SUBJECT: Forwards response to NRC 800223 ltr re LWR primary coolant sys pressure isolation valves. Surveillance tests to assess check valve status are not being performed on check valves in Event V arrangements. Flow diagrams encl.

Re: TURKEY POINT UNITS 3 & 4  
DOCKET NOS. 50-250 & 50-251  
RCS PRESSURE ISOLATION

ATTACHMENT

PTP 3

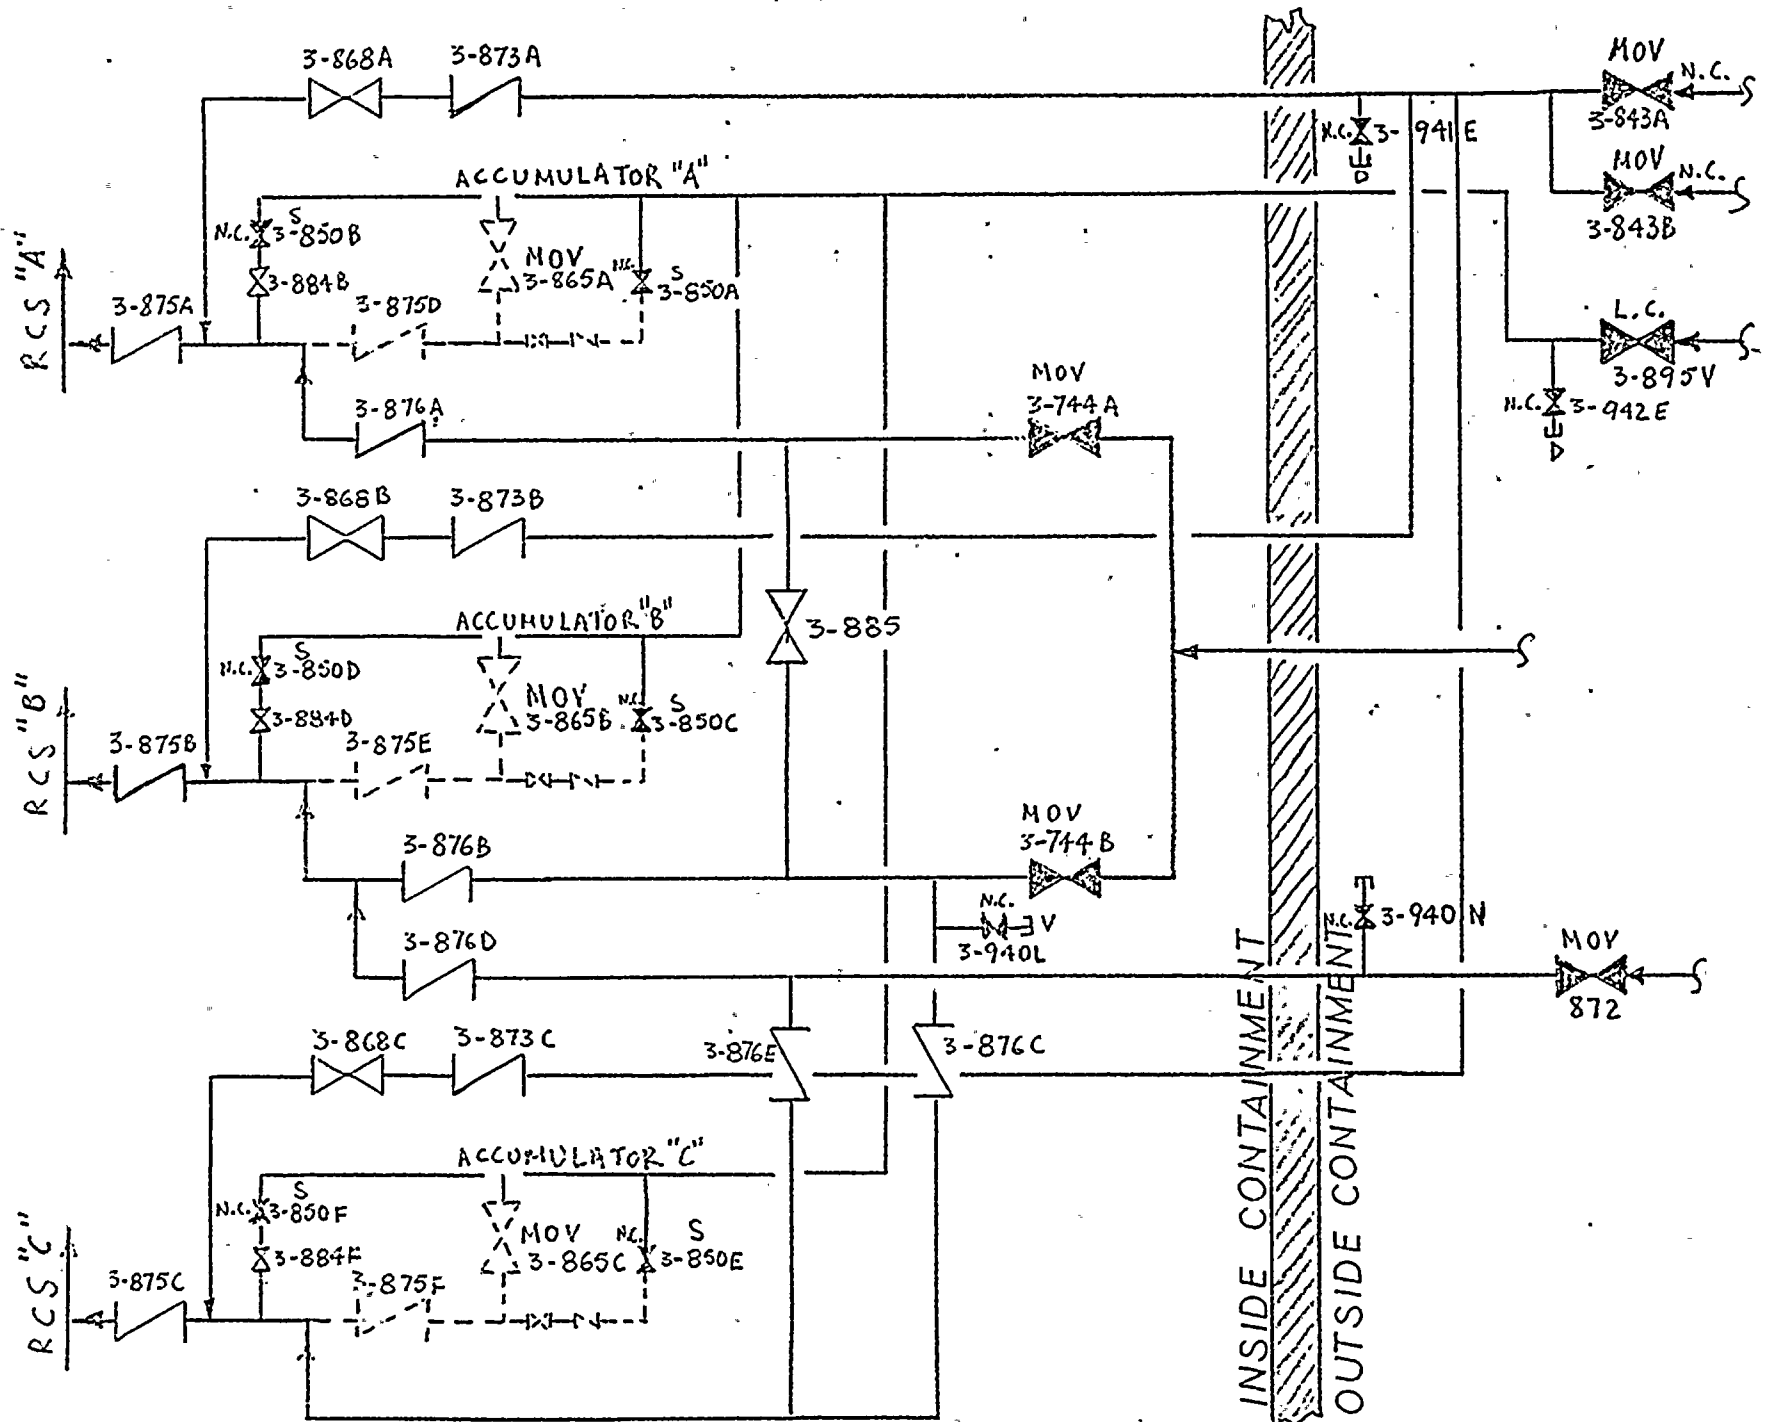
Describe the valve configuration at your plant and indicate if an Event V isolation valve configuration exists within the Class I boundary of the high pressure piping connecting PCS (Primary Coolant System) piping to low pressure system piping; e.g., (1) two check valves in series, or (2) two check valves in series with a MOV.

If either of the above Event V configurations exist at your facility, indicate whether continuous surveillance or periodic tests are being accomplished on such valves to ensure integrity. Also indicate whether valves have been known, or found, to lack integrity.

If either of the above Event V configurations exist at your facility, indicate whether plant procedures should be revised or if plant modifications should be made to increase reliability.

1. Attached are two simplified flow diagrams showing the isolation valve configurations identified as Event V arrangements for Turkey Point Units 3 & 4, respectively.

2. Specific surveillance tests to assess check valve status are not being performed on check valves in Event V arrangements at Turkey Point Units 3 & 4.

Operating procedures for Turkey Point Units 3 & 4 will be revised to provide instructions for performing and documenting periodic surveillance tests on check valve nos.: 3-875A and 4-875A  
3-875B and 4-875B  
3-875C and 4-875C

Each unit will be modified to provide for pressure measurements on the low pressure side of the check valve configurations identified as Event V arrangements. The modifications will be accomplished during the next scheduled outages of sufficient duration when the units are in the cold shutdown or refueling shutdown condition.
